## *City of El Paso – City Plan Commission Staff Report*

**Case No:** SUSU12-00065 Butterfield Trail Industrial Park Unit One  
Replat E  
**Application Type:** Resubdivision Combination  
**CPC Hearing Date:** November 1, 2012  
**Staff Planner:** Justin Bass, (915) 541-4930, [bassjd@elpasotexas.gov](mailto:bassjd@elpasotexas.gov)  
**Location:** East of Airport Drive and South of Spur 601  
**Acreage:** 14.595 acres  
**Rep District:** 2  
**Existing Use:** Industrial Development  
**Existing Zoning:** M-1 (Industrial)  
**Proposed Zoning:** M-1 (Industrial)  
**Nearest Park:** Fort Bliss Soccer Complex (0.85 mile)  
**Nearest School:** Milam Elementary School (0.71 mile)  
**Park Fees Required:** N/A  
**Impact Fee Area:** This property is not located in an Impact Fee Service Area and is not subject to impact fees.  
**Property Owner:** City of El Paso  
**Applicant:** Brock & Bustillos Inc.  
**Representative:** Brock & Bustillos Inc.

(F) NEW TRAIL AT PARKWAYS

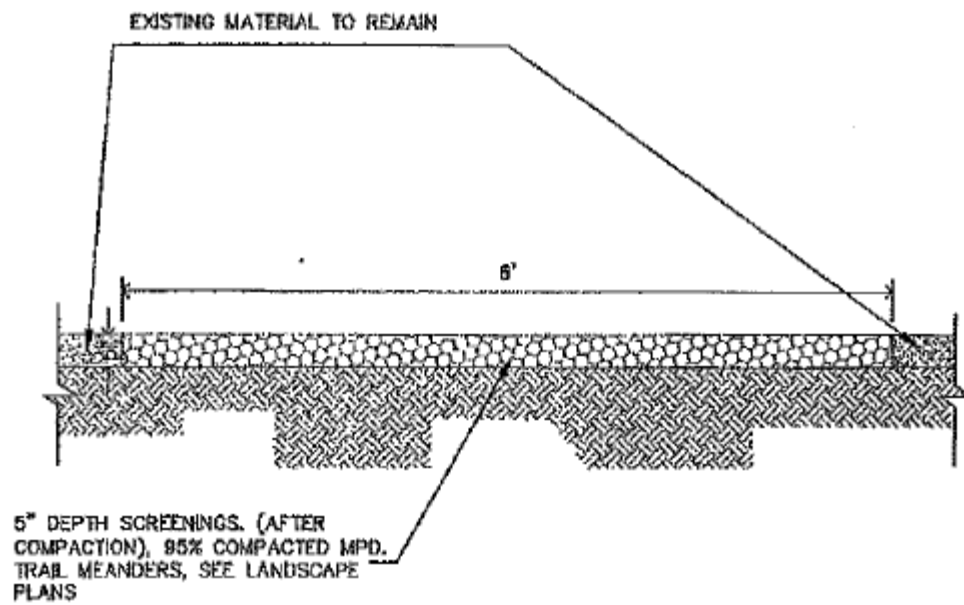
Per Section 19.26.040, the applicant is requesting an alternative subdivision improvement design for the rights-of-way, specifically regarding the design of a trail within the parkway (Attachment

No sidewalks exist in the area and no connectivity presently exists in the industrial park at all. The compacted-screenings sidewalk is not an inferior improvement to a concrete sidewalk for various reasons. In fact the compacted-screenings sidewalk (i.e., trail) reduces impact stress upon walkers and runners alike. The section of the compacted-screenings sidewalk has an improved drainage ability that will permeate storm water rather than shed it to the street, thus partially reducing the potential storm water pollution. There is also a reduction of the Urban Heat Island Effect of the compacted-screenings versus the concrete. This would make the compacted-screenings sidewalk a more eco-rational solution as opposed to concrete. The compacted-screenings sidewalk is a better than or equal to sidewalk solution than concrete. As such we recommend the alternative design.

Please find attached a detail of the cross-section of the proposed trail detail in lieu of the required concrete walkway. The trail, as shown, fully complies with the Americans with Disabilities Act and the Texas Accessibility Standards. We respectfully request that the City Planning Commission (CPC) consider a modification of materials for this small section of the replat.

Therefore, we respectfully request that the CPC favorably consider allowing the EPIA to provide an alternate material other than concrete on this portion of the improvement project that is being presented for consideration in this replat application.

**Approval with alternative subdivision improvement design.** In this case, the design has been coordinated with City of El Paso Engineering staff and has been determined to meet or exceed standards within the Design Standards for Construction manual.
